**CITY OF FREDERICKSBURG
HISTORIC REVIEW BOARD
TUESDAY, APRIL 12, 2022 @ 5:30 P.M.
LAW ENFORCEMENT CENTER at 1601 E. MAIN ST**

7. CERTIFICATE OF APPROPRIATENESS APPLICATIONS

**HISTORIC REVIEW BOARD
MARCH 15, 2022
5:30 PM**

JUDY LUCKENBACH
INTERIOR DESIGN
 412 S. Adams St. #141, Fredericksburg, TX 78624
 830.992.9044 www.judysdesignstudio.com

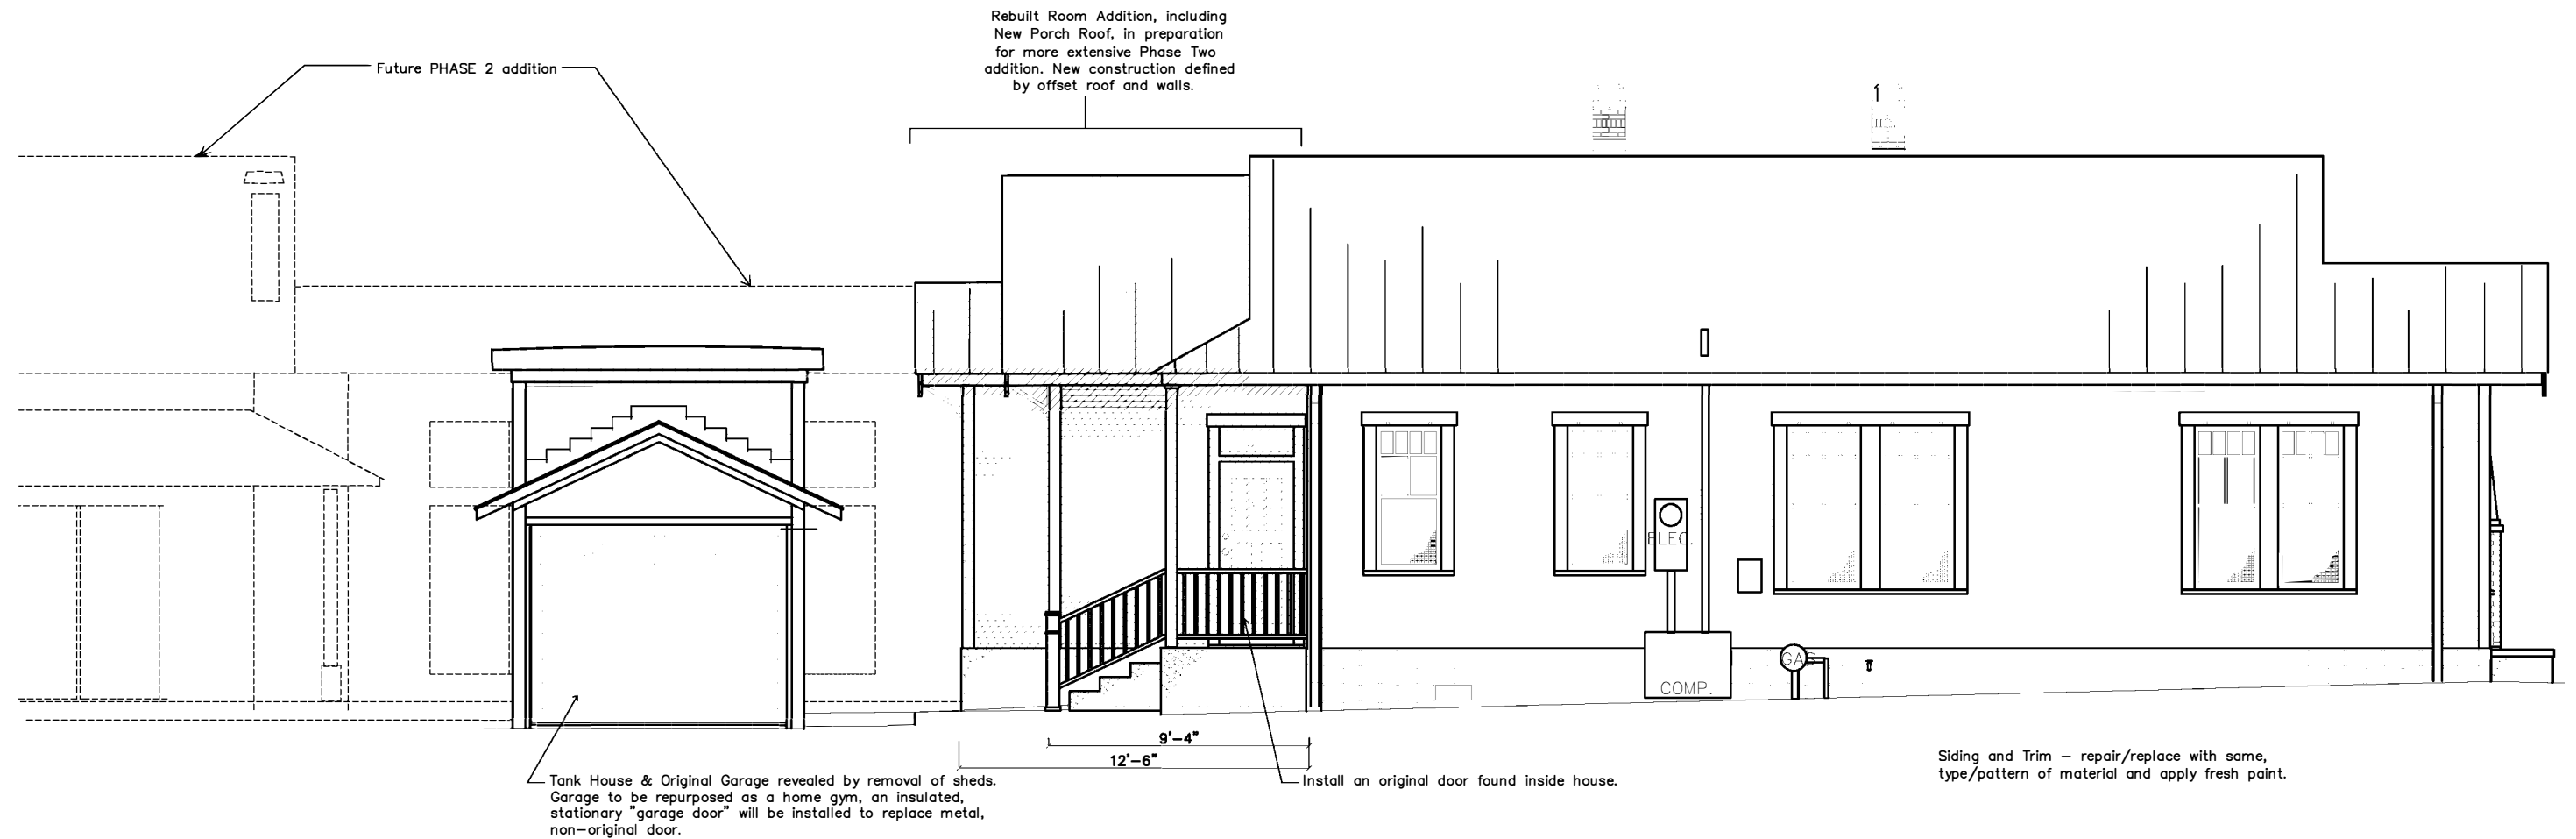
Staff recommends approval of the proposed repairs (items 4, 5, &7). The missing front porch rail should be replaced with a simple wood rail (item 6). The drawing shows a metal handrail.

The window in question is on the interior side of the lot and not readily visible from the street. The proposed re-use of the screen will help maintain the existing window pattern/design. Staff recommends approval of item 9.

JENSCHKE HOUSE

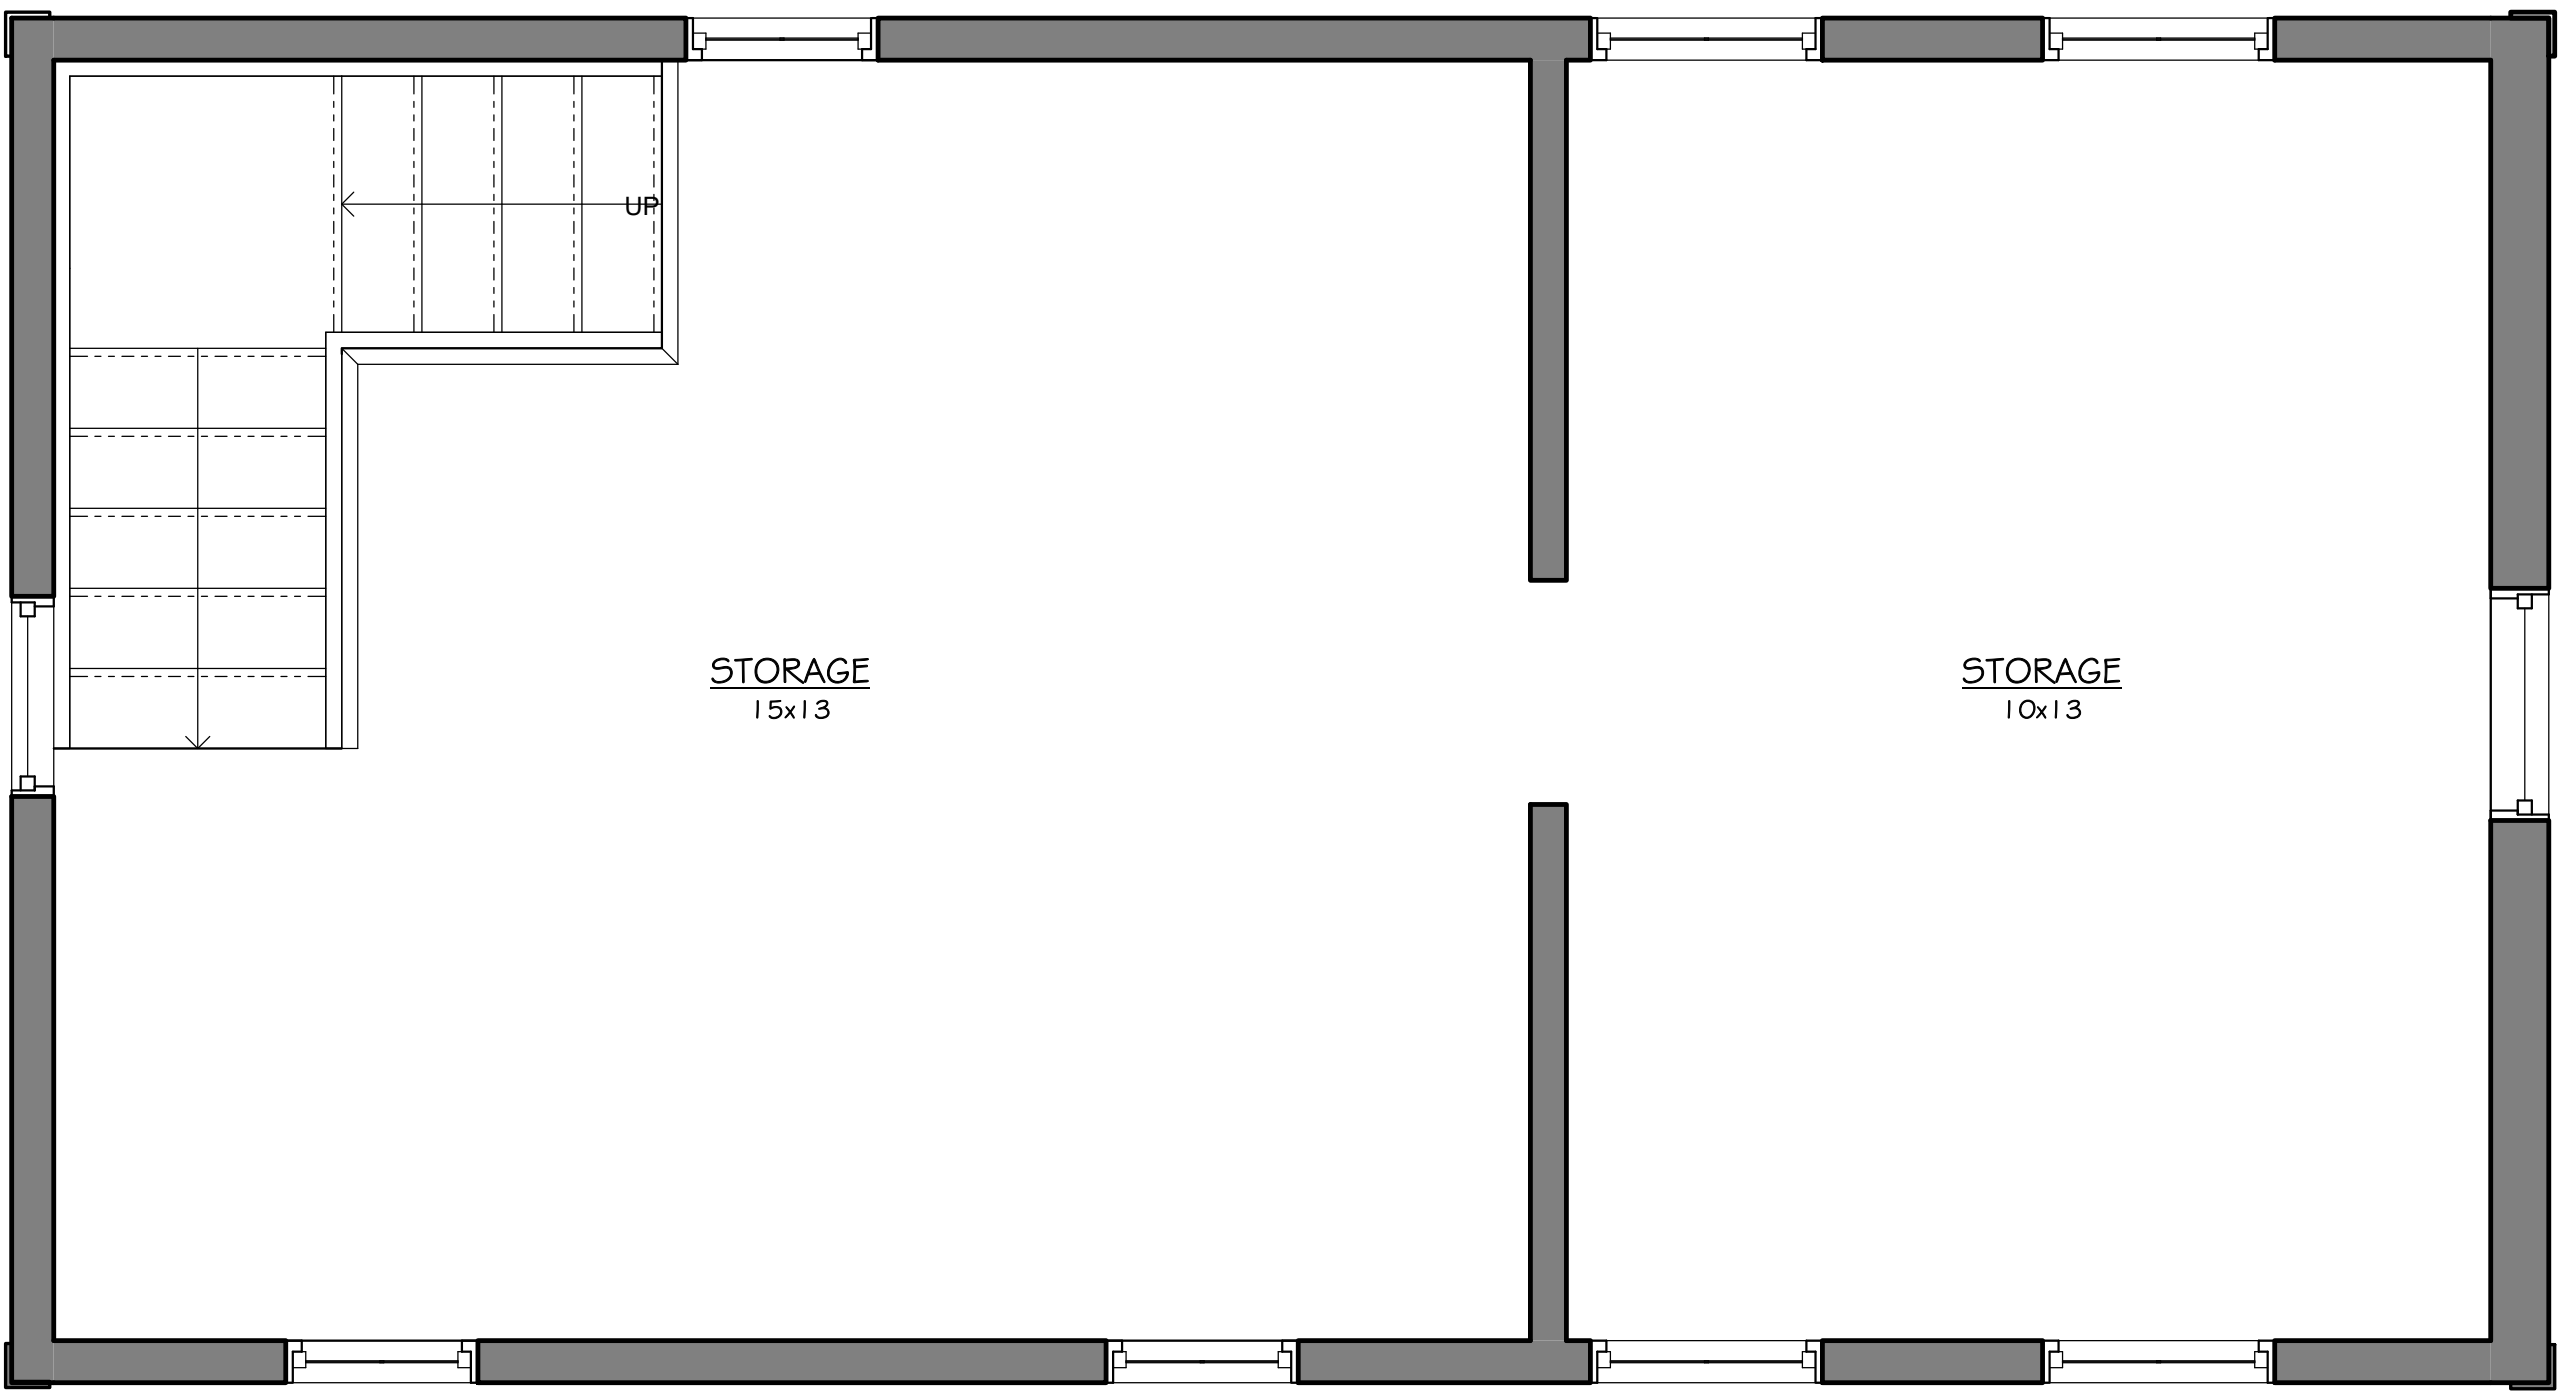
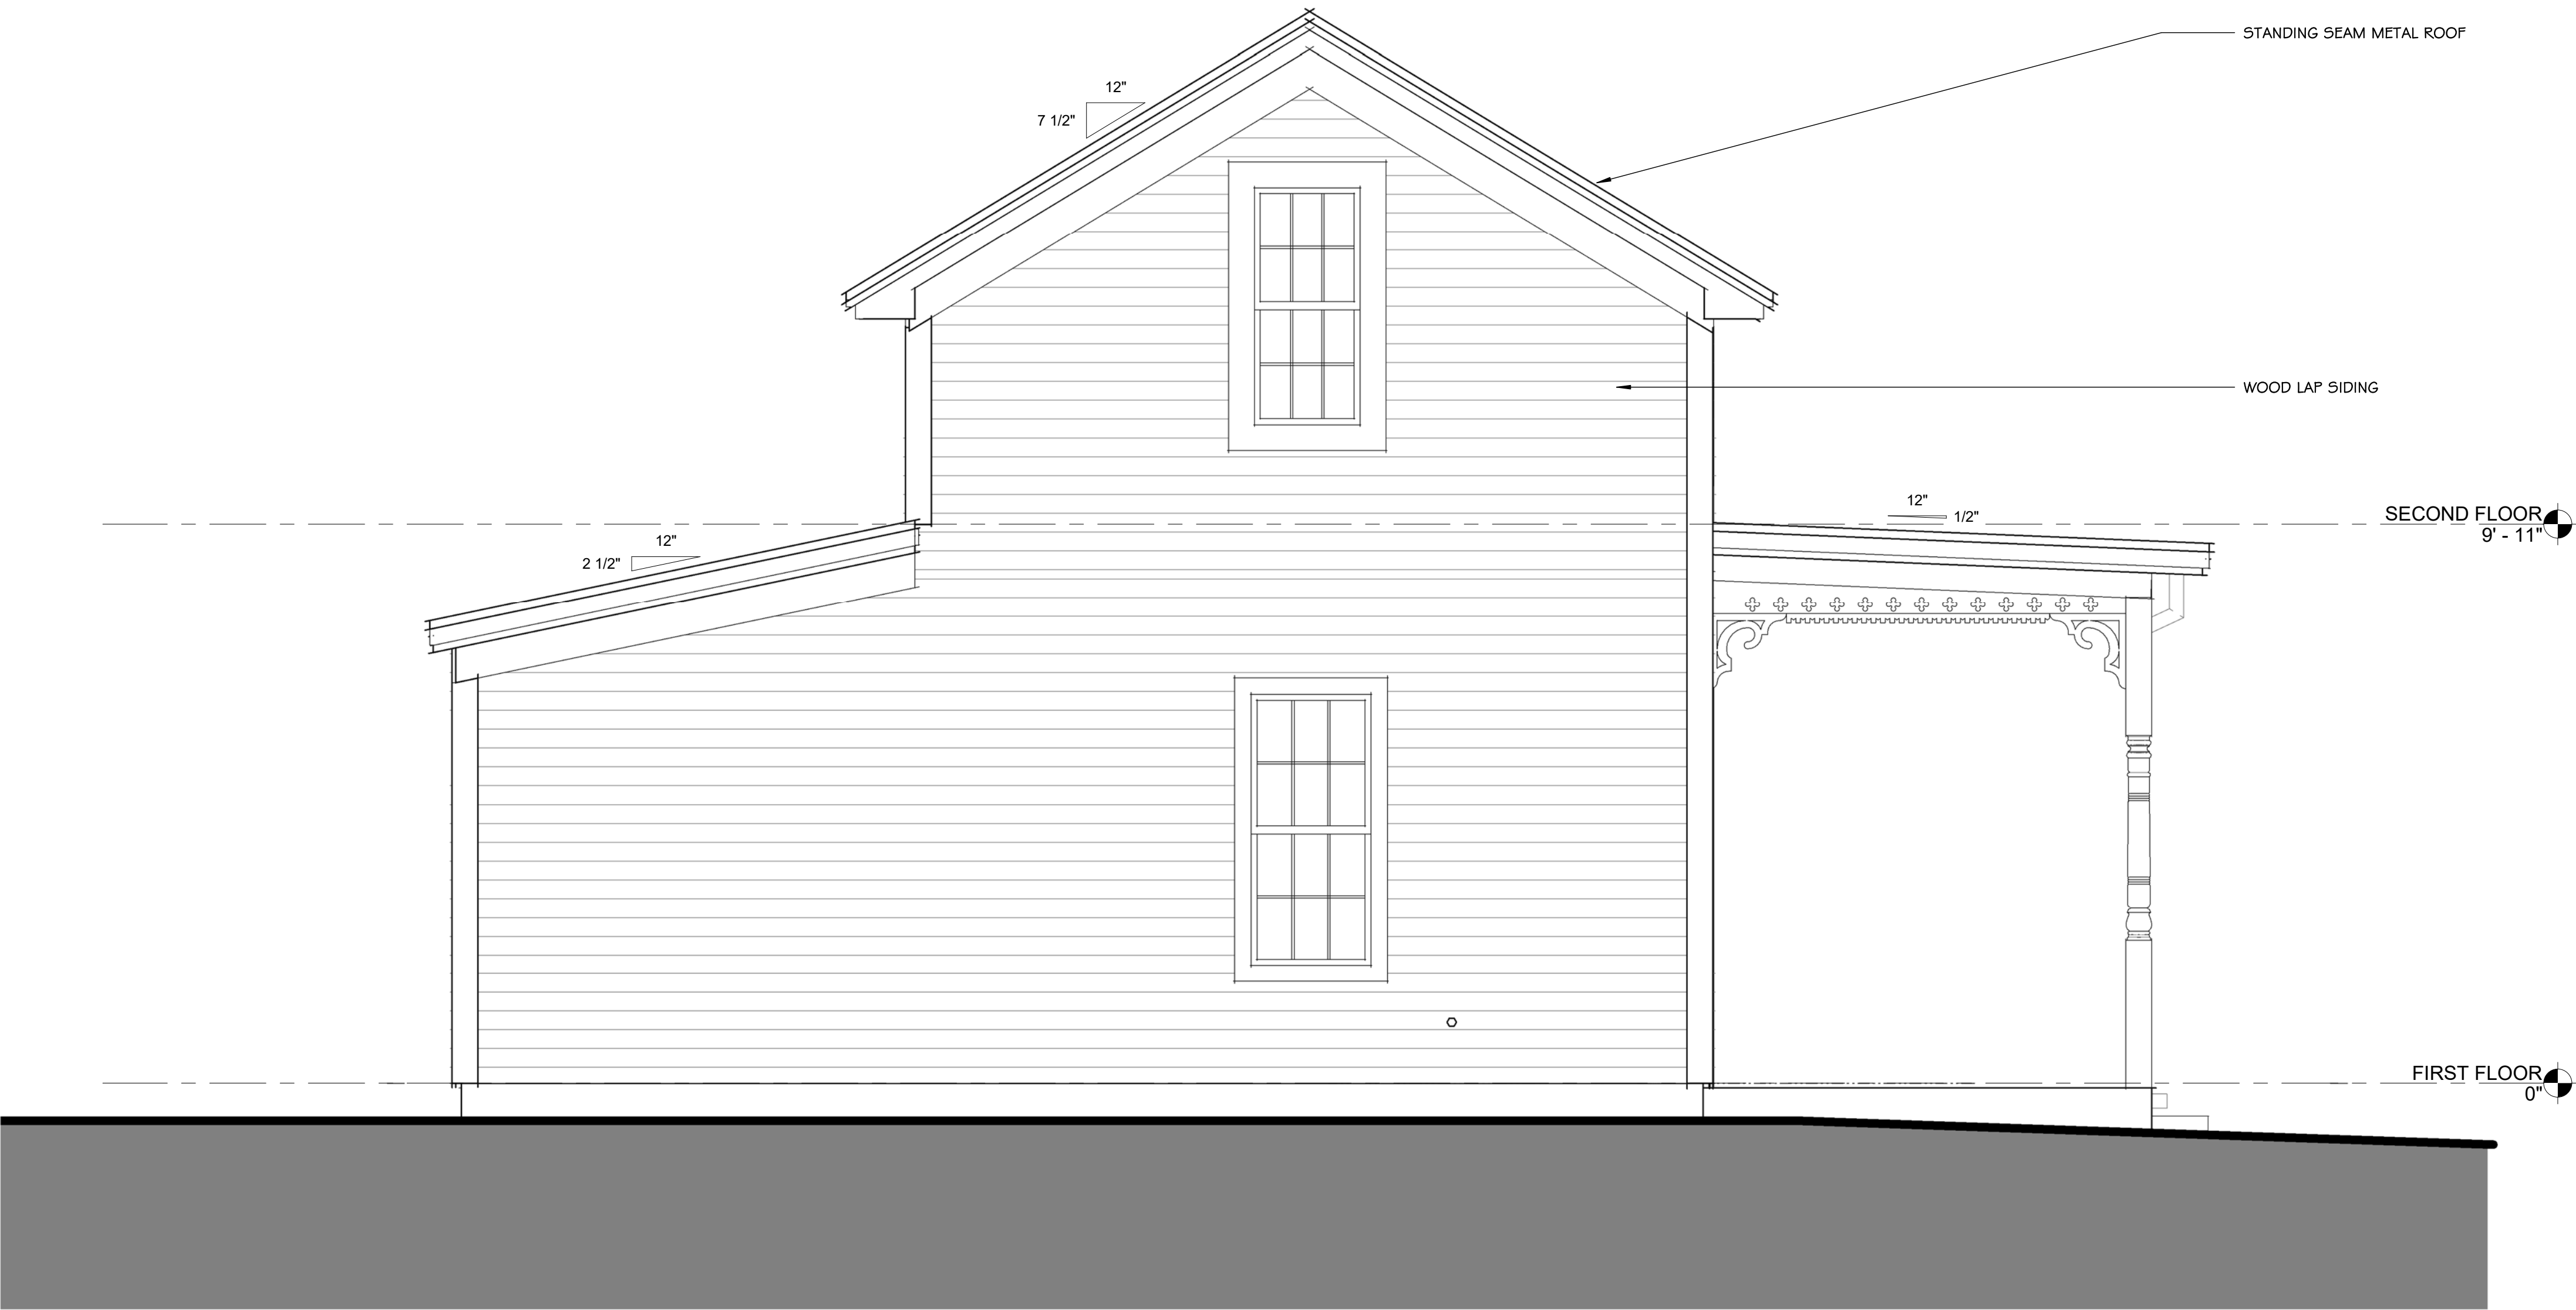
Staff commends the applicant for taking on the rehabilitation of the Jenschke House, one of only a handful of buildings in original locations on the Pioneer Museum campus. Having a few historic photos makes the rehabilitation easier to complete with less conjecture. Staff recommends approval as submitted based on historic photos and Design Guidelines/Standards.

The house has a low rating. The proposed work could bring the rating up to medium or high.

Application Number: 22-037
Date: April 12, 2022
Address: 401 E College
Zoning: R1
Owner: D4 FBG Holdings
Applicant: Krista Duderstadt
Rating: Medium
Proposal: replace wood windows with wood – aluminum clad casement windows.

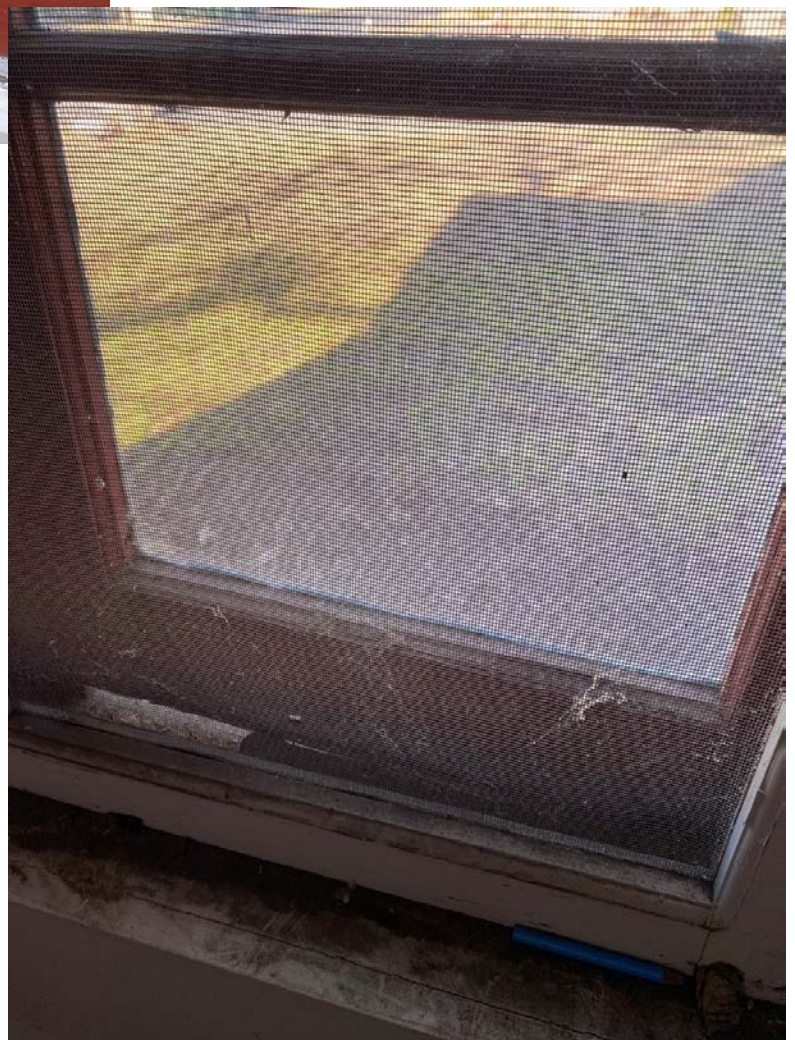
The windows in question appear to be of historic age, but likely not original as the rest of the windows in the original section of the house are double-hung. The proposed replacement is designed to replicate the light pattern and size of the existing. Staff recommends approval based on the Design Guidelines/Standards referenced above for medium rated structures.

Staff recommends approval of the proposed paint colors based on previous tenant's recollection of color.
